# SERVICE BULLETIN

## M1534: POLICE - SPEAKER BRACKET

This bulletin informs dealers that Harley-Davidson has identified Police models that have an obsolete bracket (Part No. 76000856) installed, which can damage the front fender while operating.

Figure 1. Bracket Part No. 76000856A

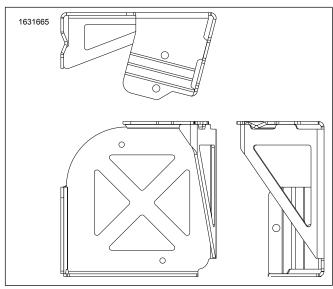
- See Figure 1. If dealer has inventory of bracket Part No. 76000856A, no action is required.
- See Figure 2. If dealer has inventory of bracket Part No. 76000856, remove part from inventory. File a Defective Stock (DFS) warranty claim. Refer to Table 3.
- If dealer has inventory of Audio Kit (76001039), check kit. If kit has bracket Part No. 76000856A, no action is required. If kit has bracket Part No. 76000856, remove part from kit. File a Defective Stock (DFS) warranty claim. Refer to Table 3. Order replacement bracket (Part No. 76000856A) using the standard part ordering process and replace kit with new bracket
- If motorcycle has obsolete bracket installed, remove and replace with new bracket. Submit warranty claim. Refer to Table 2.
- If front fender is damaged, receive authorization to remove and replace damaged fender.
